**Subject: Intermittent Slow to Cool HVAC Performance Concerns in High Ambient Temperatures and/or High Humidity Conditions After Start Up, Especially at Low Engine Speeds (Install New Engine Cooling Fan Clutch)**

**Models: 2004-2005 Buick Rainier  
2002-2005 Chevrolet TrailBlazer Models  
2002-2005 GMC Envoy Models  
2002-2004 Oldsmobile Bravada  
2005 Saab 9-7X**

**This bulletin is being revised to provide repair information for this customer concern. Please discard Corporate Bulletin Number 04-01-38-019 (Section 01 -- HVAC).**

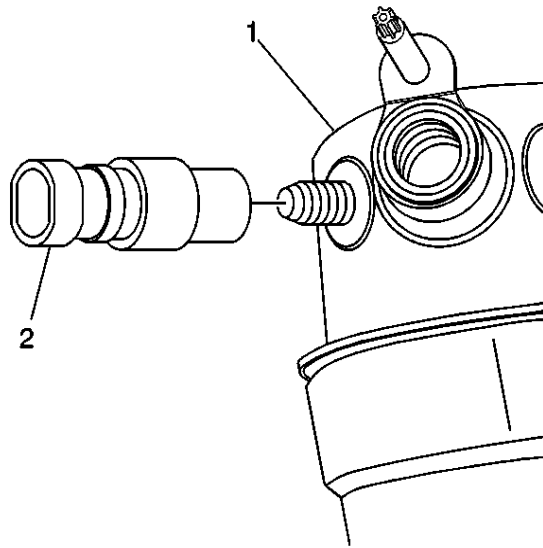
18. If the compressor is not operating as designed, tap on the low pressure cycling switch (2) with a small hand tool. The compressor should start operating correctly.
19. If the compressor does not operate correctly after tapping on the low pressure cycling switch (2), disconnect the switch and jumper the lower pressure cycling switch connector with a fused jumper. If the compressor still does not operate properly, refer to HVAC Compressor Clutch Does Not Engage diagnostic in SI.

20. If the compressor does operate correctly after tapping on the switch or jumping the low pressure cycling switch connector, replace the low pressure cycling switch (2), P/N 89040362. Refer to Air Conditioning (A/C) Low Pressure Switch Replacement in SI.
21. Perform the Air Conditioning (A/C) System Performance Test in SI.
22. Disconnect the J 43600 ACR 2000 Air Conditioning Service Center.
23. Remove the fender covers and close the hood.
